# CITY OF ALBUQUERQUE

**RE: Durango Subdivision, Units 3 - 5  
Tr H, Durango Unit 1 & Tr A Durango Unit 3A  
Drainage Report Stamp Date: 3/5/15  
Unit 3 Grading Plan Stamp Date: 8/12/15 (Approved for Plat, 8/18/15)  
Unit 3A Grading Plan Stamp Date: 1/18/19  
Unit 4 Grading Plan Stamp Date: 8/12/15 (Approved for Grading, 8/18/15)  
Unit 5 Grading Plan Stamp Date: 1/18/19  
Hydrology File: C09D012**

Based on the submittal received on 1/18/19 the above-referenced Grading Plans cannot be approved until the following are corrected:

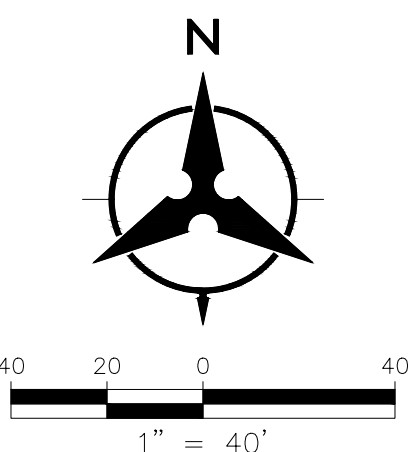
2. Show the storm drain network on the Grading Plan (vicinity of Unit 3A); delineate which portions have been constructed (any portion of the storm drain that hasn't been constructed and accepted will need to be added to the infrastructure list).

3. Existing and proposed contour labels are missing for Unit 3A. In Unit 5, please increase the density of existing and proposed contours along the external boundaries. The slope indicators appear to be reversed along the 4:1 tie-in slope.

4. Provide a temporary pond on Coal Bank St where Unit 4 ties in (Unit 3A). Prior to Unit 3 ROFG, a temporary drainage easement on the temporary ponds will be needed, unless the upstream road portions have been built.

5. How will flows be directed from the west side of Coal Bank St to Red Mountain Rd (Unit 3A)? It appears that a valley gutter is needed here.
6. Identify internal retaining walls to be constructed by the developer (prior to Pad Cert) and those to be deferred to homebuilder. Any wall retaining 2 feet or more will need to be

<b>CITY OF ALBUQUERQUE PUBLIC WORKS DEPARTMENT</b>	
<b>DURANGO UNIT 5 GRADING AND DRAINAGE PLAN</b>	
Design Review Committee	City Engineer Approval
Mo./Day/Yr.	Mo./Day/Yr.
City Project No.	Zone Map No.
C-09-Z	Sheet 1 Of 3

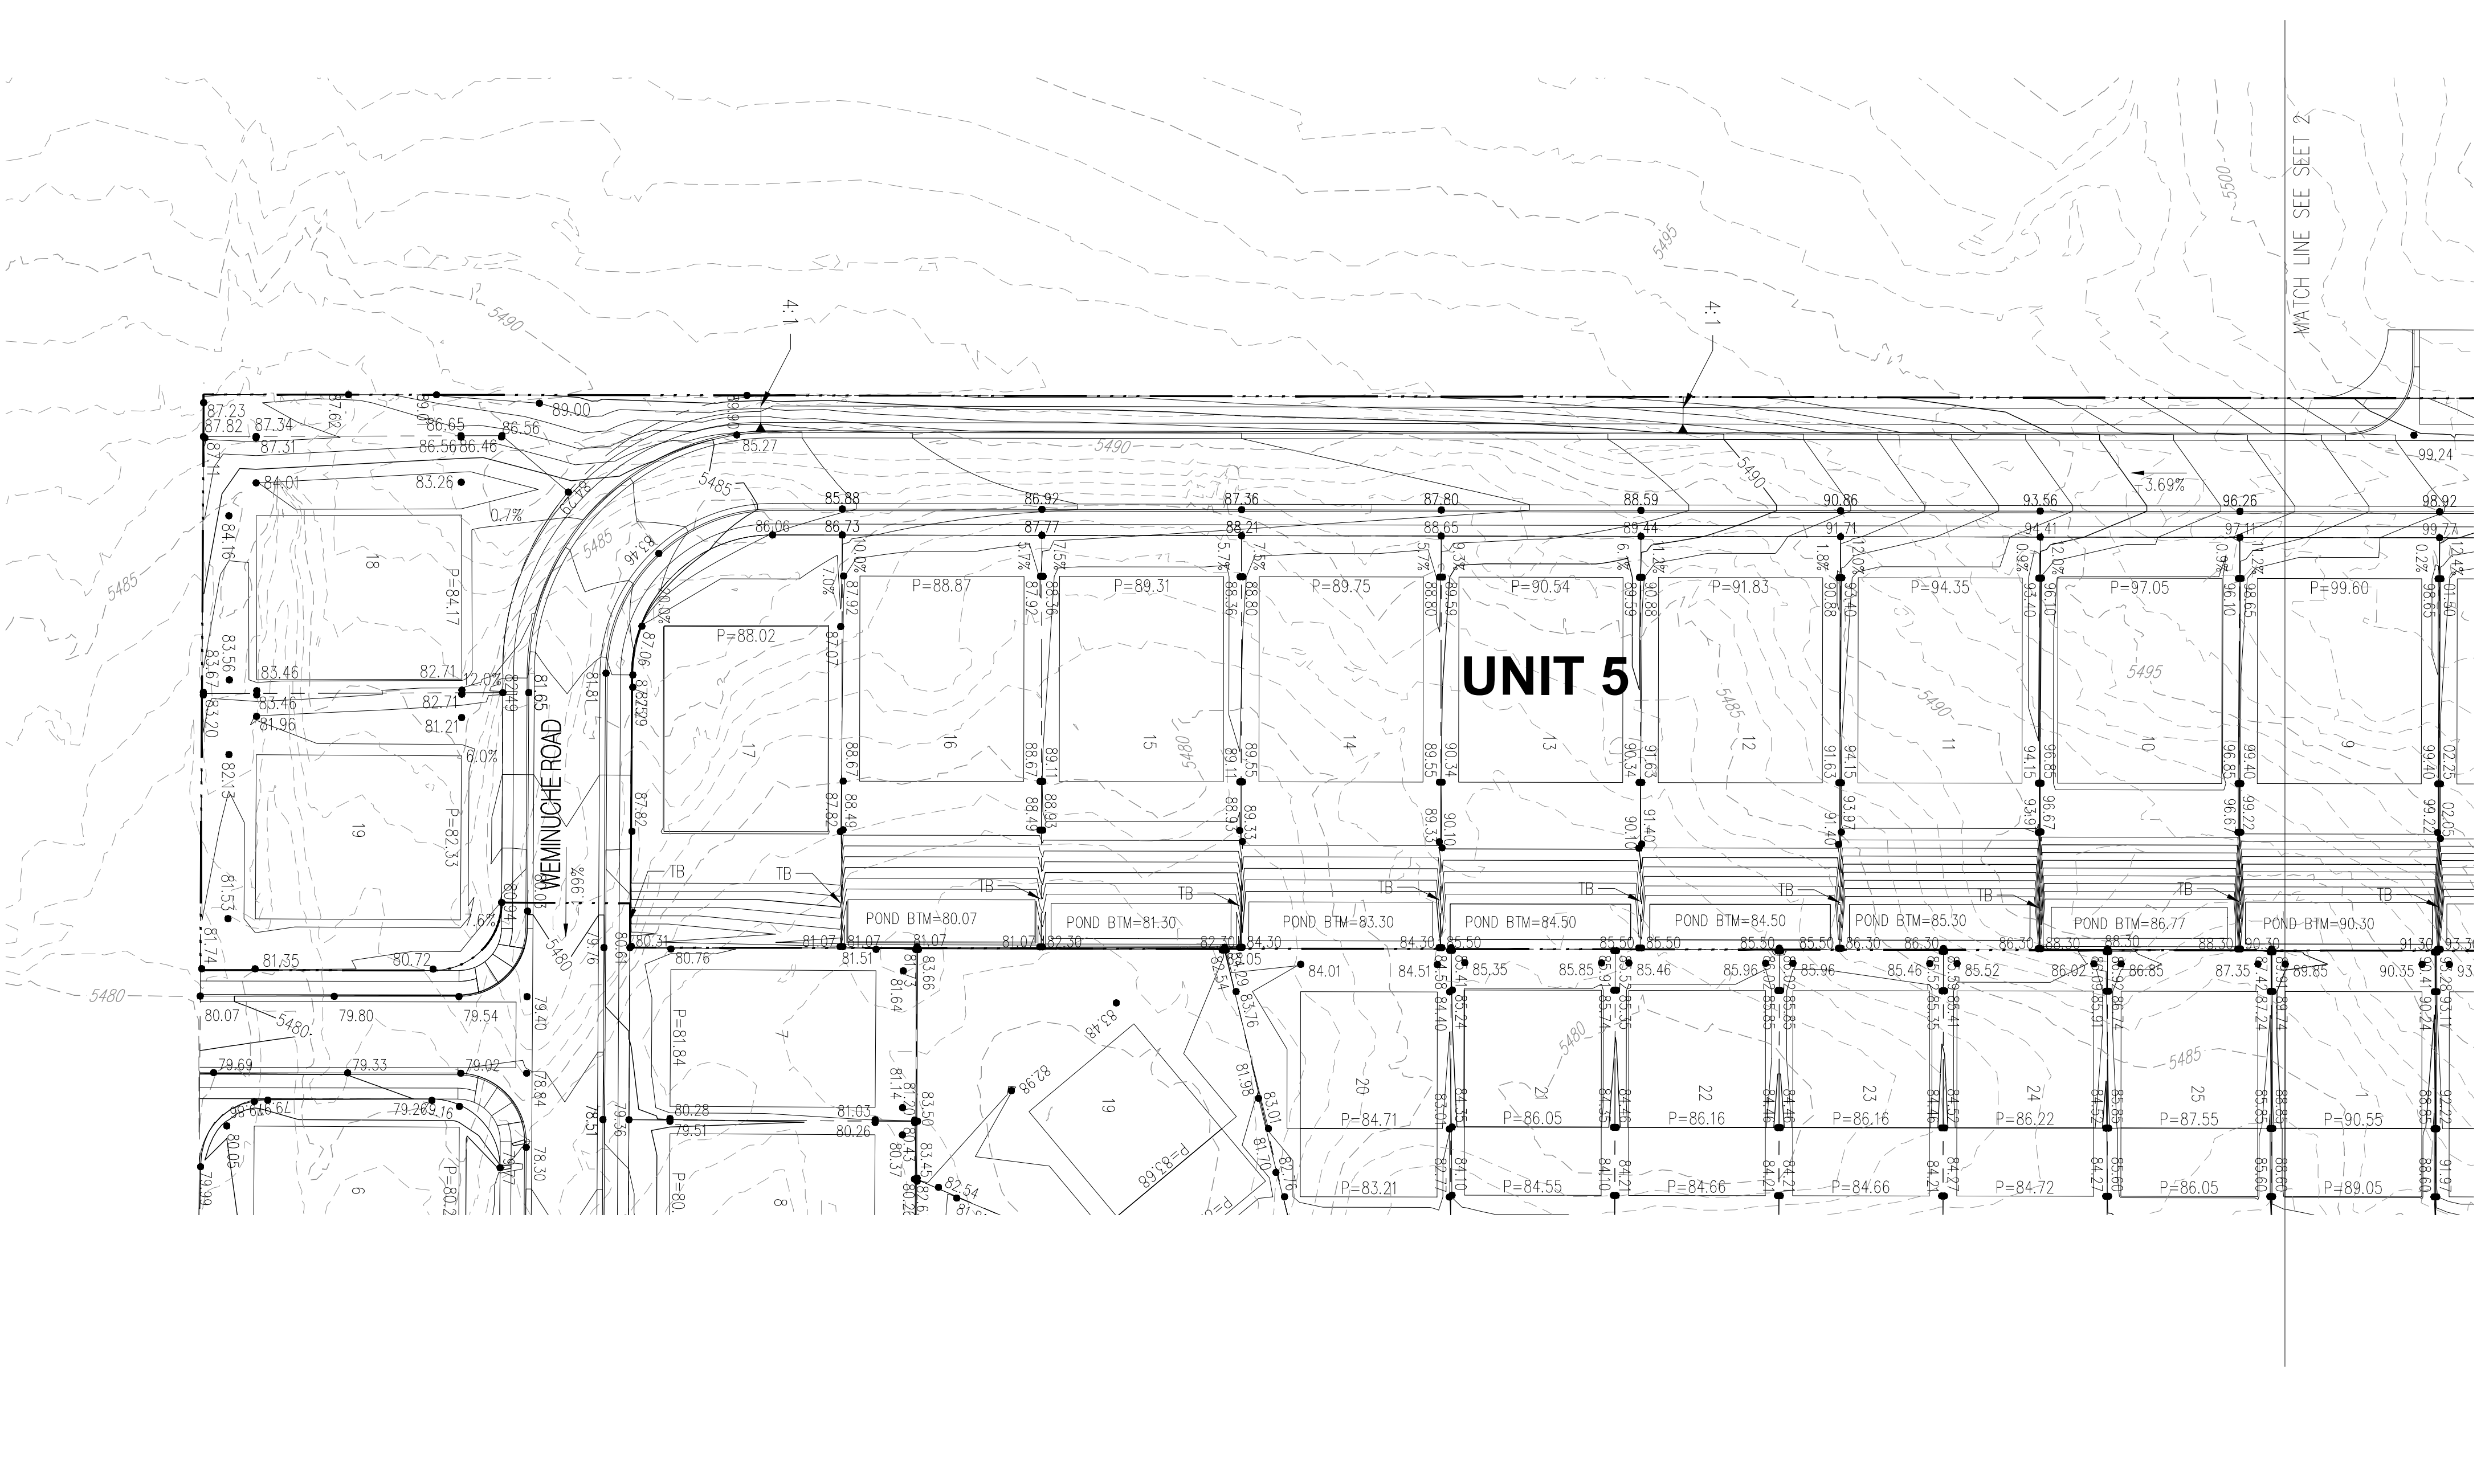
10. Provide written permission from City Open Space for grading and construction of the drive entrance on their property (across from Lot 8, Unit 5).
11. The backyard ponds for Lots 4-16, Unit 5 need a protective covenant; either a restrictive covenant for the homeowner's (enforced by HOA) or a [Drainage Covenant \(No Public Easement\)](#) to ensure these ponds don't become a hazard for the homeowners in Unit 3. However this is resolved, a recorded document will be needed at Final Plat (provide a draft when resubmitting).

13. Include typical lot grading details on the Grading Plan; one for all of the backyards that drain to the streets via sideyard swales and one for lots in Unit 5 with the backyard ponds.
